City Council Staff Report

Consideration of an Ordinance to rezone 13.5 acres from A-2 to RA-1 with a TDR-R and approve a preliminary plat application for 13 lots located at approximately 1200 West and 400 South.

Development Review Committee Minutes

On October 2, 2020 plans were submitted for the Larsen subdivision consisting of a rezone from A-2 to RA-1 with a TDR-R Overlay and a 13 lot subdivision. The items below include 1) requested changes to the submitted plans, 2) other items required as part of the application and/or 3) informational items regarding city standards.

LARSEN SUBDIVISION PLAT "A"

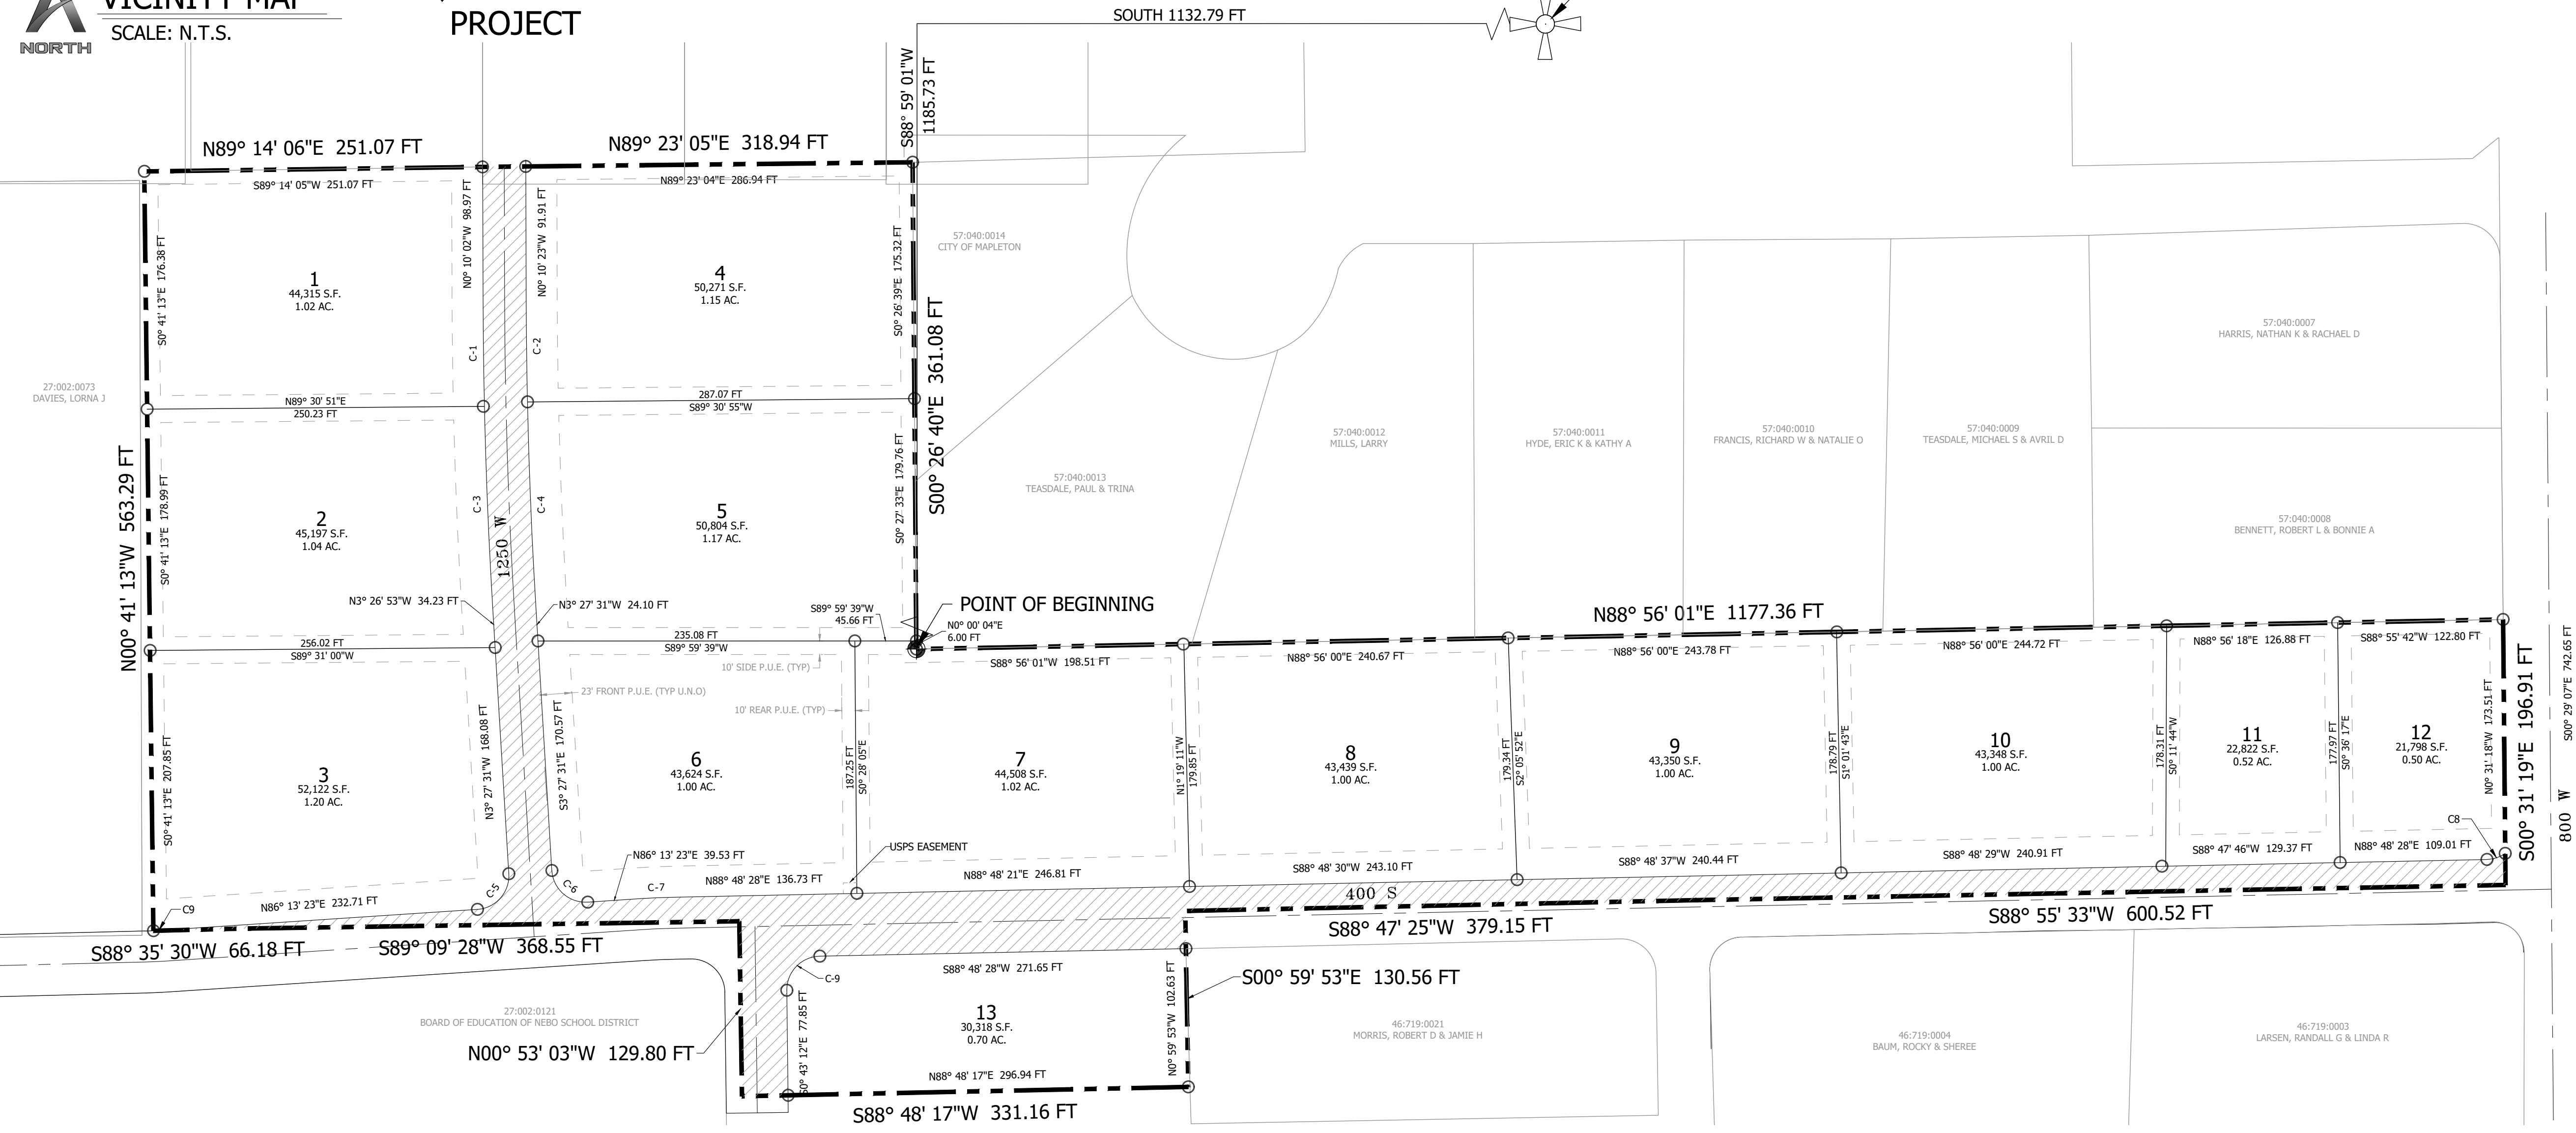
1. The application will require approval of a Rezone to RA-1 with a TDR-R and the use of one TDR certificate.
2. Please note on the plat that lots 3 and 6 must get their primary access from 1250 W not 400 N.
3. Include the attached addresses on the plat.
4. Add a signature line for the Community Development Director under Planning Commission approval and remove the signature lines for the City Attorney and County Recorder under Legislative Body. Also, remove the Utah County Recorder signature block section.
5. A temporary turnaround meeting fire department requirements must be included at the north end of 1250 W.
6. Mailbox cluster may not be located on 400 South
7. A reimbursement payment of \$112,541 is due to Nebo School District.
